### WEST KENTISH TOWN CONSERVATION AREA ADVISORY COMMITTEE

# Comments on planning application 2020/6019/P, 58 Malden Road, NW5

Basement flat: grille above window to kitchenette

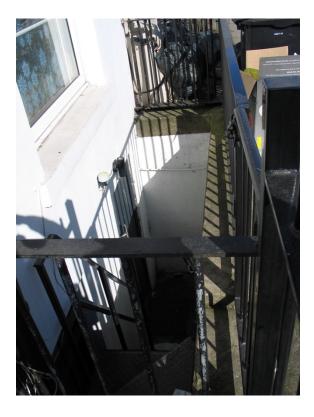
• The new basement flat created has no outlook, it is completely below ground level and has practically no natural light. Although there are two windows- one to a kitchenette and one to a bedroom- they look straight onto a brick wall.
